FMB001 Product Change Notifications

Main Page > OBD Trackers > FMB001 > FMB001 Product Change Notifications

2021.01.01: Top Laser Printing Changes

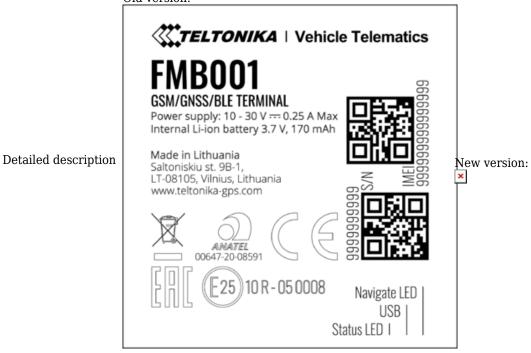
Top laser printing design changed

1. Updated Emark certificate number.

- 2. Added UKCA label.
- 3. Updated Teltonika brand to Teltonika Telematics.
